Access Compliance Report

Public Rights-of-Way

(Curb Ramps)

Intersection ID: 13010	Main Street: HICKORY GROVE RD	Cross Street: DOGWOOD PL	Location: NW
ADA ID: F15847D87B10	Ramp Type: PerpDiag	Initial Pass/Fail: Fail	Overall Compliance: No
Codes/Mitigation Info/Possible Solution		Field Measurements/Component Compliance

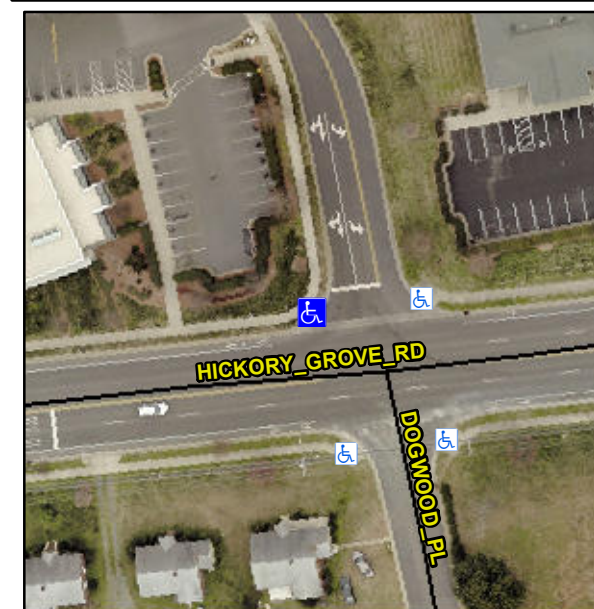
Not Found, R304.5.1, R304.2.2

Compliance	Description	Data	Compliance	Description	Data
N/A	Ramp Length (in)	47.0	No	Ramp Slope (%)	8.4
No	Ramp Width (in)	46.0	Yes	Ramp XSlope (%)	0.4
N/A	Flare Type LT	N/A	N/A	Flare Type RT	N/A
N/A	Flare Slope LT (%)	N/A	N/A	Flare Slope RT (%)	N/A
N/A	Flare Traversable LT?	N/A	N/A	Flare Traversable RT?	N/A
N/A	Landing Length (in)	N/A	N/A	DWS Provided?	N/A
N/A	Landing Width (in)	N/A	N/A	DWS Contrast?	N/A
N/A	Landing Slope (%)	N/A	N/A	DWS Length (in)	N/A
N/A	Landing X Slope (%)	N/A	N/A	DWS Full Width?	N/A
N/A	Landing Curb? (Y/N)	N/A	N/A	DWS Offset (in)	N/A
N/A	Shared Landing?	N/A			
N/A	Gutter Ponding?	N/A	N/A	Gutter Slope (%)	N/A
N/A	Gutter Lip Ht (in)	0.5	N/A	Gutter X Slope (%)	N/A
N/A	Painted X Walk1?	No	N/A	Painted X Walk2?	No
	X Walk 1 Direction	To S		X Walk 2 Direction	To E
N/A	X Walk 1 Width (in)	N/A	N/A	X Walk 2 Width (in)	N/A
	X Walk 1 Slope (%)	0.8		X Walk 2 Slope (%)	1.8
	X Walk 1 X Slope (%)	0.2		X Walk 2 X Slope (%)	2.3

Remove & Replace Curb Ramp With Two New Directional Ramps or Equivalent.
